# Intimate Creations Limited

28<sup>th</sup> September 2021

# Observations

Floor loading has been shown 4 kPa for 2<sup>nd</sup> floor at Storage area.

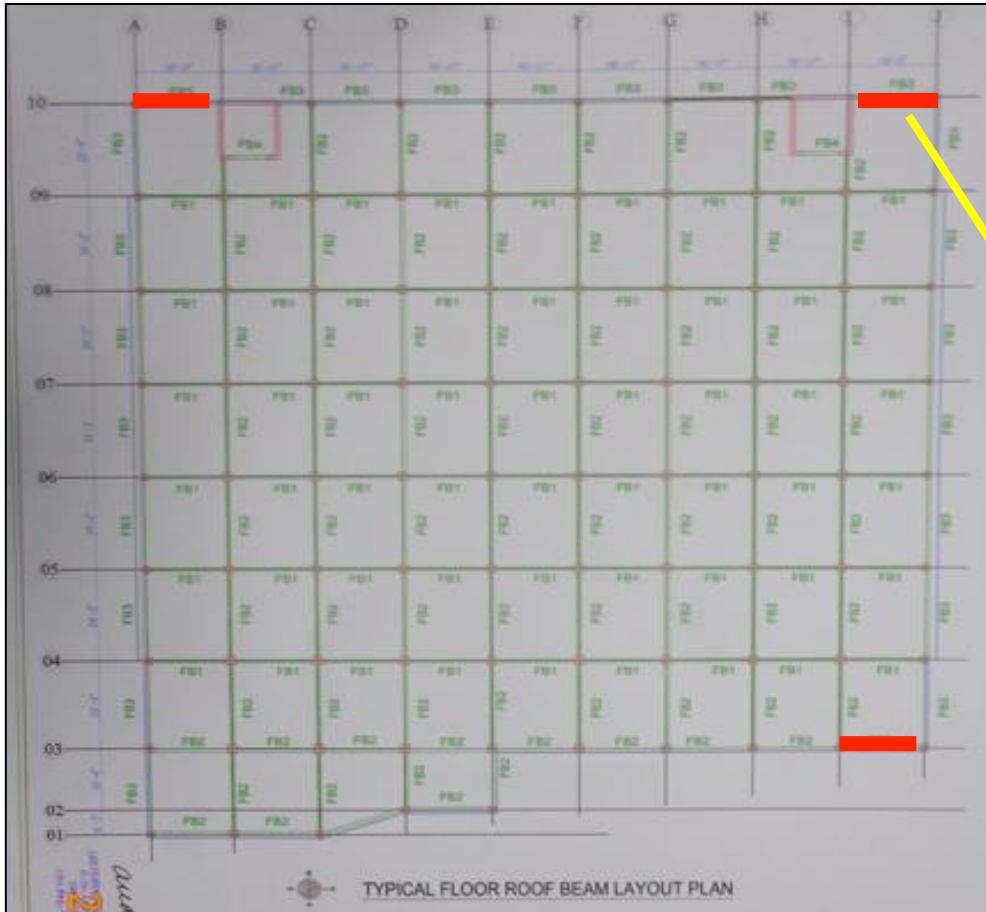
In Design report floor loading has been considered (105 psf) 5 kPa which do not match with posted load plan in floor.

As per BNBC, minimum 6 kPa live loading is required to be considered for the light storage facilities. During inspection, load plan was found posted considering (84 psf) 4 kPa at 2<sup>nd</sup> floor.

As per BNBC, every building or structure designed shall have its design documents prepared in accordance with the provision of Section 1.9.1. Now, the factory engineer is required to revise design report the structure as per BNBC 2006.

**Non-engineered shed on roof (RO plant)**

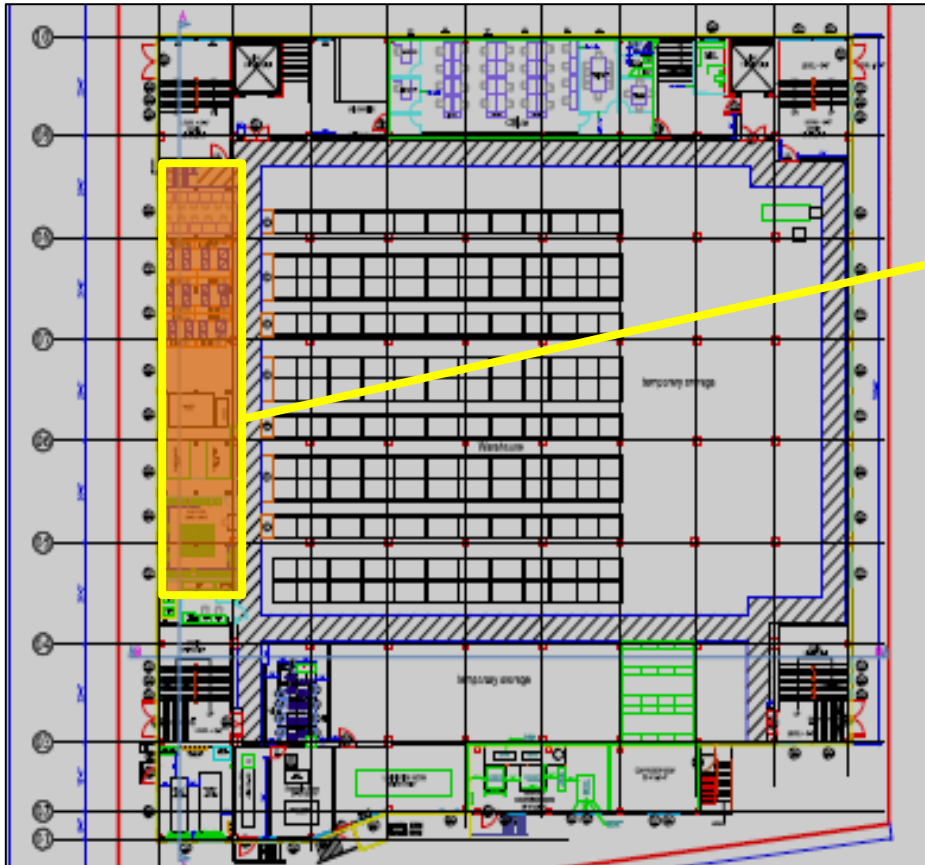
Non-engineered shed. The factory engineer is required to replace the non-engineered shed with an engineered one.

Light weight roof supported on peripheral wall

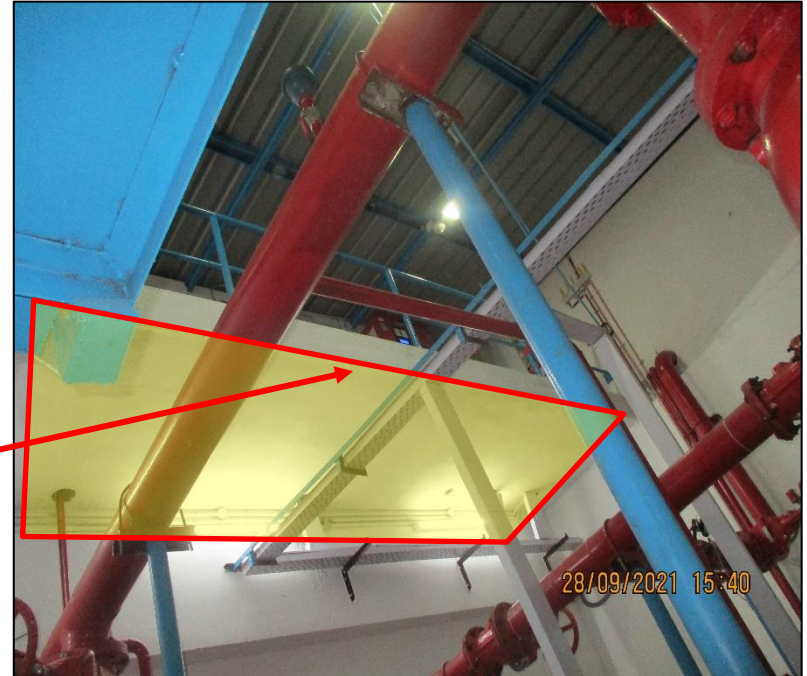
Non-engineered connection

Roof of pump room is apparently non-engineered. C-channel rafter is embedded in peripheral brick wall. Building engineer to check the stability of the lightweight roof structure against lateral loading and if inadequate then replace the structure with an engineered one.

# Non engineered steel stair

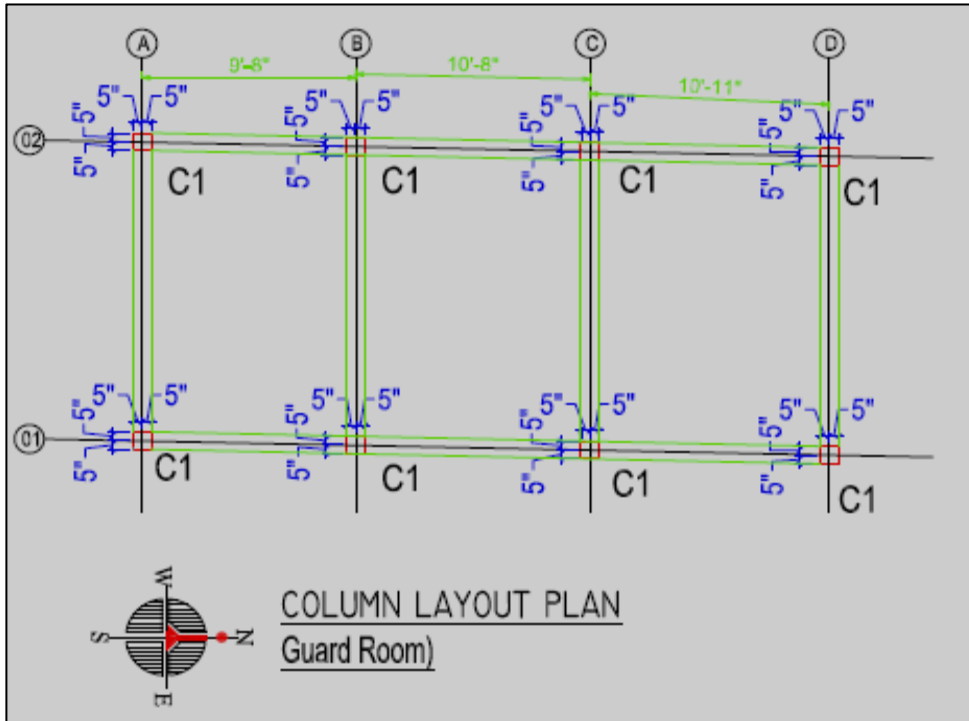
Apparently inadequate connection was observed at steel stair of pump Room. Factory engineer is required to carry out connection adequacy check of the steel stair.
